SUNDRY NOTICES AND REPORTS ON WELLS

8. Well Name and No.
DOS EQUIS 11-14 FEDERAL COM 4H

Cimarex respectfully requests approval to change the SHL and BHL of the Dos Equis 11-14 Federal Com 4H well. Cimarex also requests approval to change the completion formation to Wolfcamp. The additional surface disturbance was approved by Cody Layton.

Approved:
SHL: 470 FNL & 370 FEL
BHL: 330 FSL & 360 FWL
Proposed:
SHL: 530 FNL & 370 FWL
BHL: 100 FSL & 330 FWL

Cimarex ST01 Rev 0

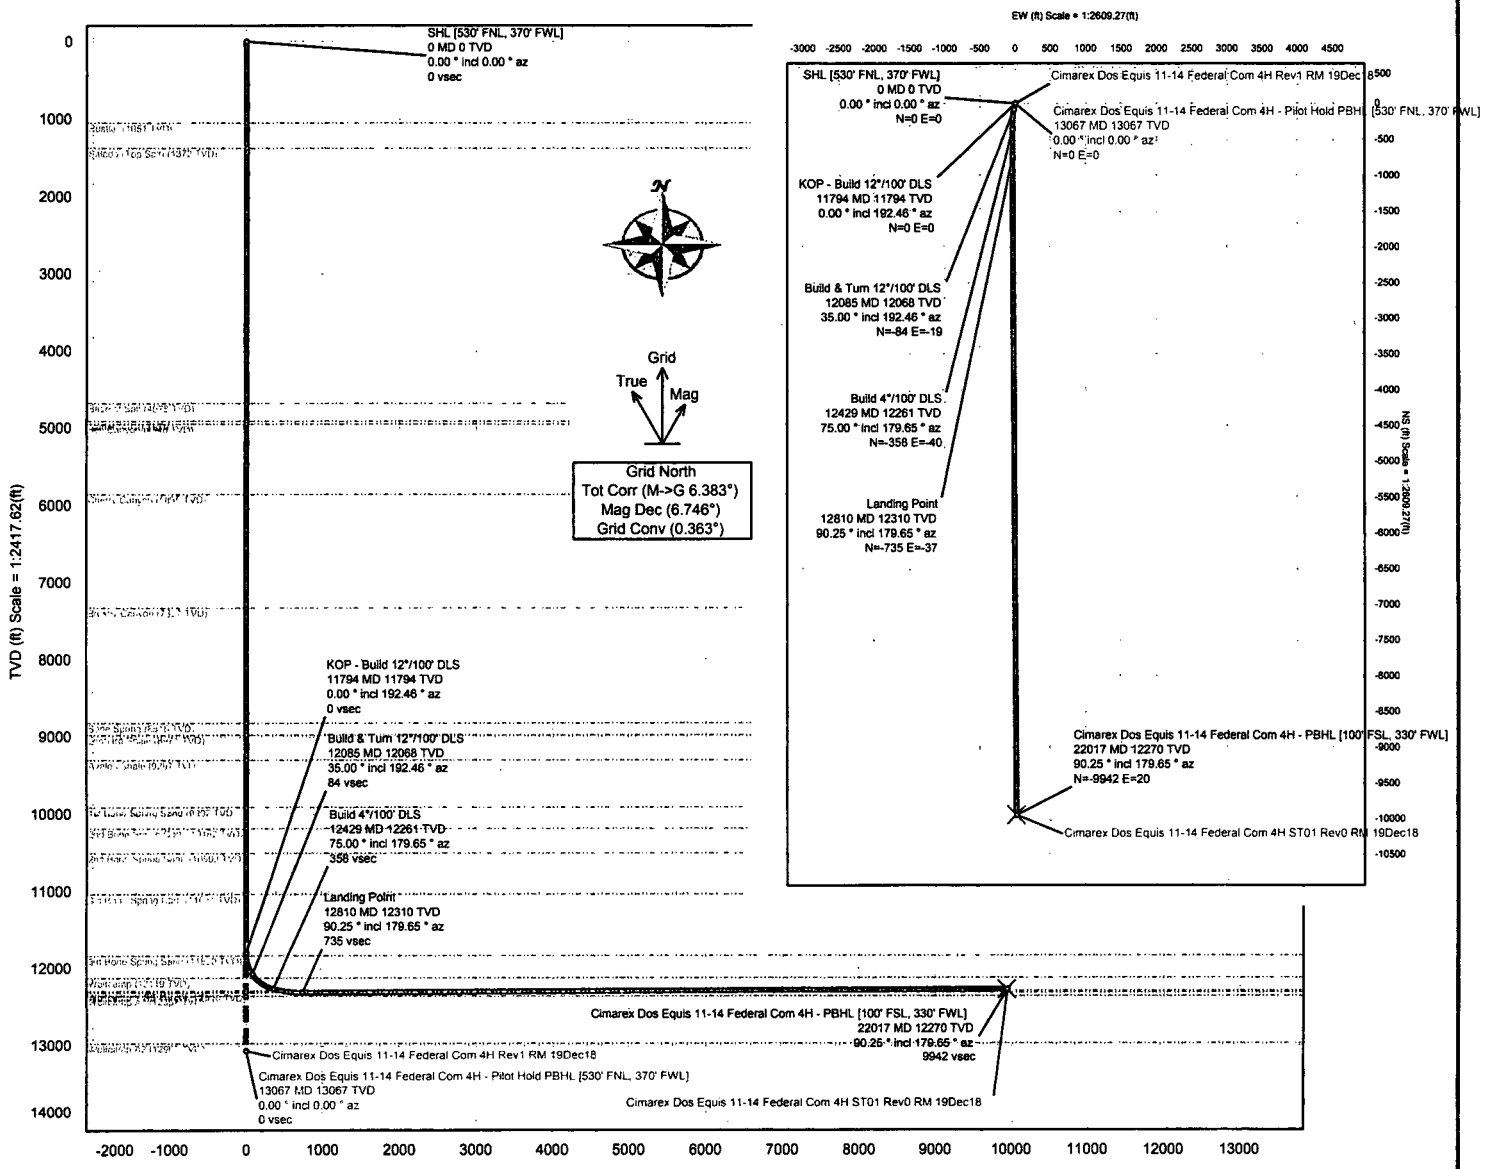
Please see attached plat, directional plan, and drilling plan for changes.
